**LITCHFIELD AFFORDABLE HOUSING  
PROJECT**

LITCHFIELD,  
CONNECTICUT

Environmental Review Team Report

Litchfield Inland Wetlands Commission

Conceptual Site Plan

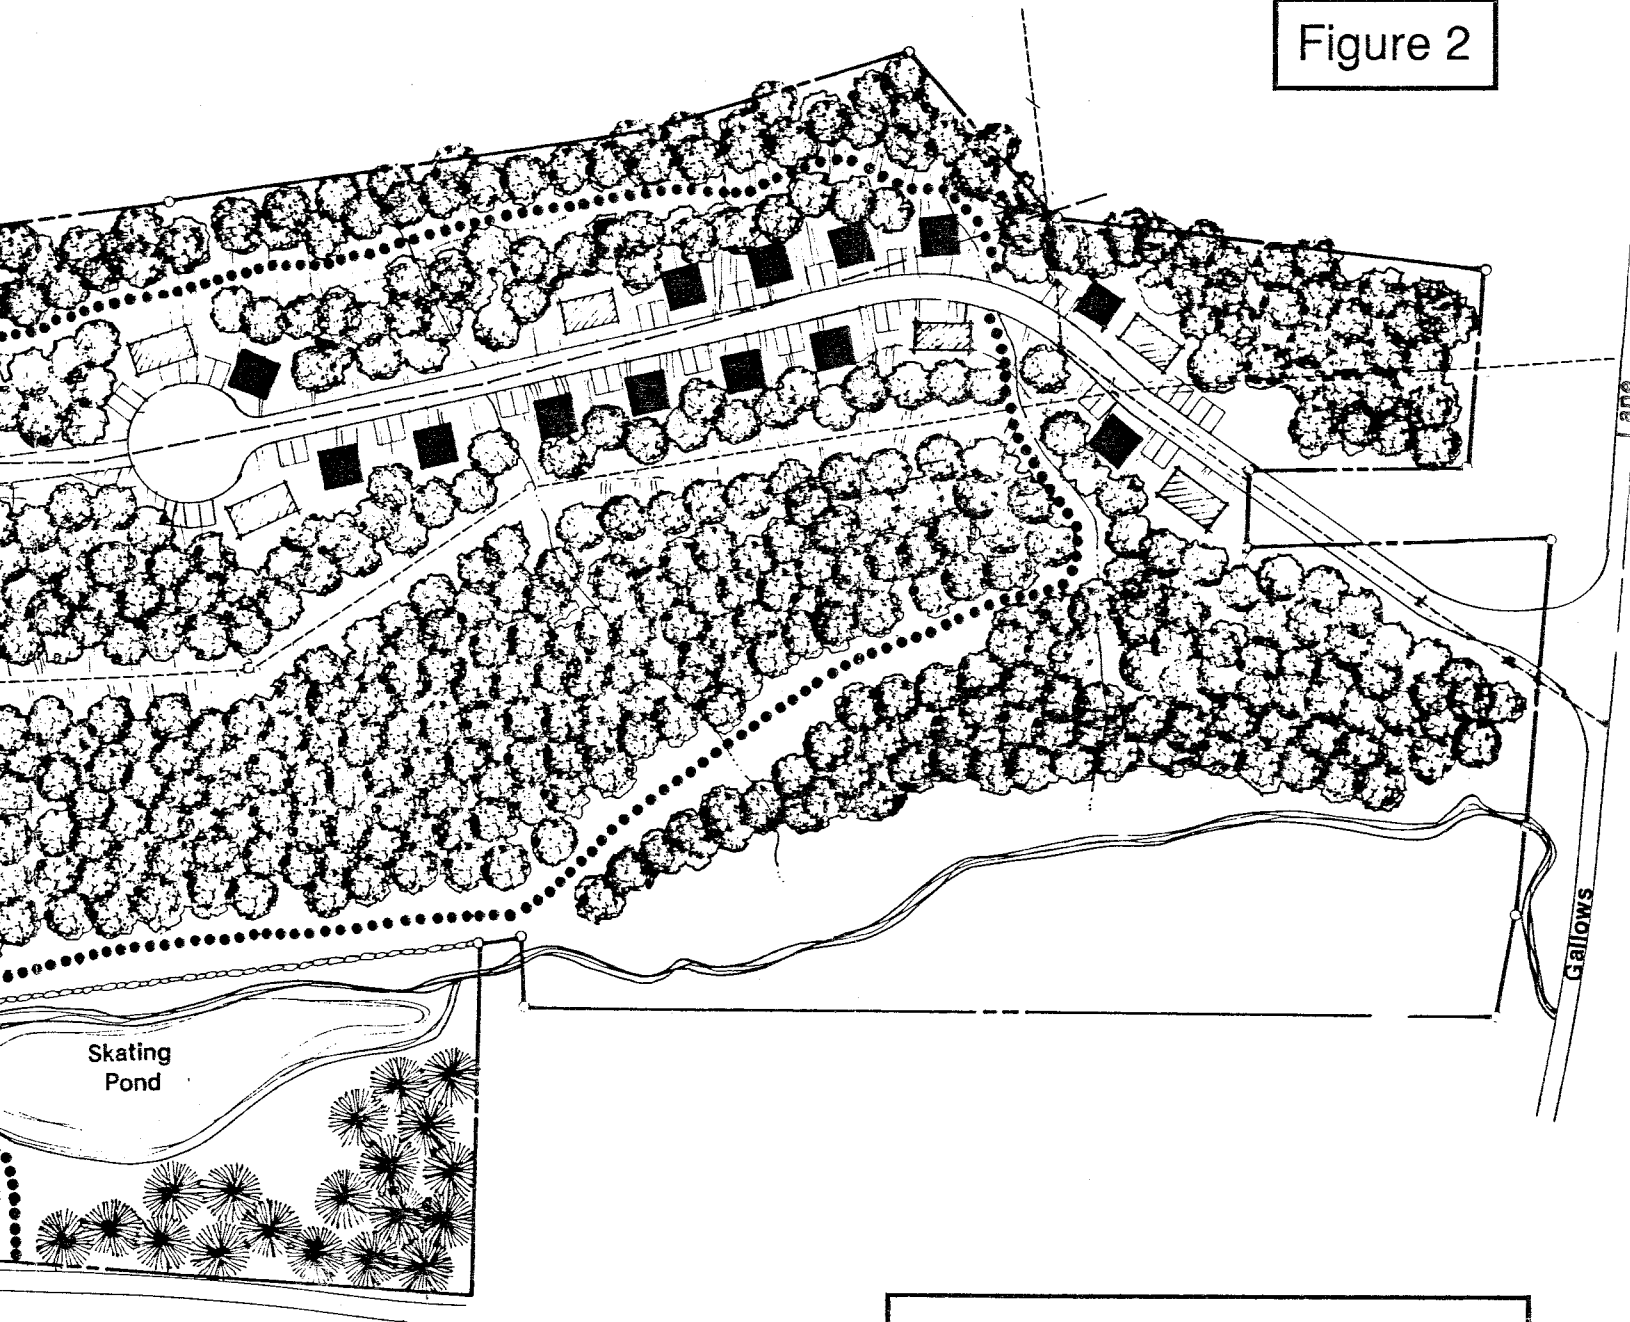
The preliminary plans show developing the shallow pond on Russell Street for skating. The pond contains high value aquatic and emergent habitat and also provides a sediment trap for Tannery Brook. The pond should not be disturbed. A skating pond could be built on the Rd soils with the proper permits, if desired.

Based on the site plan, the present road layout would result in several crossings of the wetlands on the site. There is evidence of past wetland disturbances on-site. Depending on the final layout, driveways and grading may also affect wetlands. In addition, several houses would be placed on regulated wetlands soils under the present proposal. There appears to be some flexibility for the realignment of roads, which would result in less of an impact on the wetlands within the site. It is strongly suggested that these alternative routes be considered. There also appears to be some flexibility for clustering homes on non-wetland soils, perhaps at higher densities, especially with the availability of municipal sewers, thereby reducing the number of houses on wetland soils.

The preliminary site plans show the shallow pond on Russell Street to be used as a skating pond. This pond area currently provides a high value shallow water/emergent aquatic vegetation habitat for wildlife that is somewhat unique in the area. The shallow pond also serves as a sediment retention area for sediment in Tannery Brook. For these reasons, the pond should not be disturbed.

Building and Road Placement: It is very important that final plans for buildings and roads on this site respect the extensive wetland areas. An estimated 72% of the site consists of regulated wetland soils. The conceptual plan for the property infringes substantially on these wetland areas. A conscientious attempt to locate housing units in non-wetland areas is recommended. Cluster housing is an alternative which the community may wish to consider in order to minimize disturbance to wetland soils.

If a pond is desired on the property for skating or fire protection, it may be possible to construct one in the Rd soil type. The source of water for this pond would be the seasonal high water table. Locating a pond in one of the numerous drainageways on the site would increase water flow into the pond. Some areas of Rd soils are wetter than others. The pond should be located in the wetter range of this soil.
